Access Compliance Report

Public Rights-of-Way

Intersection ID: 49125	Main Street: LEGOLAS_LN	Cross Street: LAVETA_RD	Location: SE
ADA ID: 011DDFC09056	Ramp Type: PerpDiag	Initial Pass/Fail: Fail	Overall Compliance: No
		Severity Score: 8.75

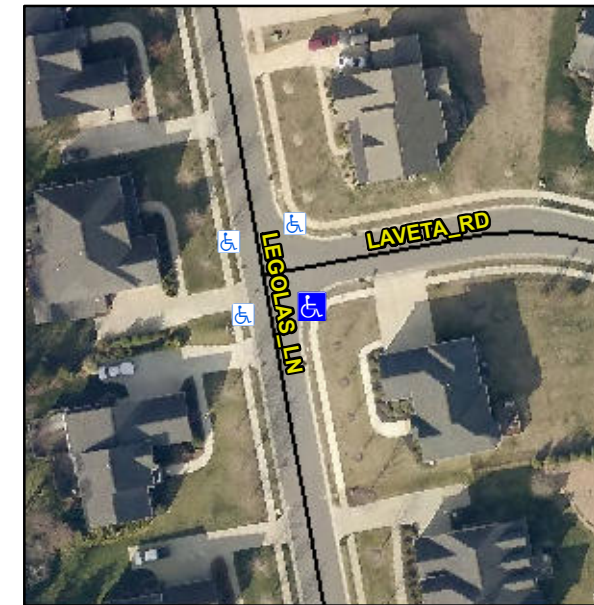
Not Found, R304.5.1

Compliance	Description	Data	Compliance	Description	Data
N/A	Ramp Length (in)	47.0	Yes	Ramp Slope (%)	7.1
No	Ramp Width (in)	45.0	Yes	Ramp XSlope (%)	1.7
N/A	Flare Type LT	N/A	N/A	Flare Type RT	N/A
N/A	Flare Slope LT (%)	N/A	N/A	Flare Slope RT (%)	N/A
N/A	Flare Traversable LT?	N/A	N/A	Flare Traversable RT?	N/A
N/A	Landing Length (in)	N/A	N/A	DWS Provided?	N/A
N/A	Landing Width (in)	N/A	N/A	DWS Contrast?	N/A
N/A	Landing Slope (%)	N/A	N/A	DWS Length (in)	N/A
N/A	Landing X Slope (%)	N/A	N/A	DWS Full Width?	N/A
N/A	Landing Curb? (Y/N)	N/A	N/A	DWS Offset (in)	N/A
N/A	Shared Landing?	N/A			
N/A	Gutter Ponding?	N/A	N/A	Gutter Slope (%)	N/A
N/A	Gutter Lip Ht (in)	N/A	N/A	Gutter X Slope (%)	N/A
N/A	Painted X Walk1?	No	N/A	Painted X Walk2?	No
	X Walk 1 Direction	To N		X Walk 2 Direction	To W
N/A	X Walk 1 Width (in)	N/A	N/A	X Walk 2 Width (in)	N/A
	X Walk 1 Slope (%)	3.1		X Walk 2 Slope (%)	1.2
	X Walk 1 X Slope (%)	0.9		X Walk 2 X Slope (%)	3.2

Remove & Replace Curb Ramp With Two New Directional Ramps or Equivalent.
